Recommendations from Imtac on public realm proposals for Portaferry town centre

(October 2019)

About this report

The Historic Built environment

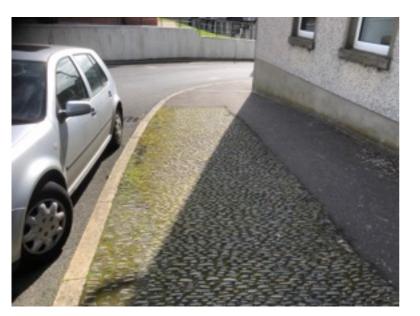
The historic nature of the streets in Portaferry creates multiple issues for pedestrians, and older people and disabled people in particular. On both Ferry Street and Castle Street there are large sections of the street with no footway. Sections of footway alternate between both sides of the road along both streets.

Where there are footways these are obstructed in places by the historic building lines including stepped access to buildings.

Topography

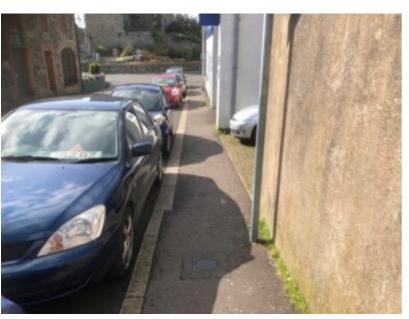
The topography of the site is challenging in places with steep gradients and cross falls on the footway.
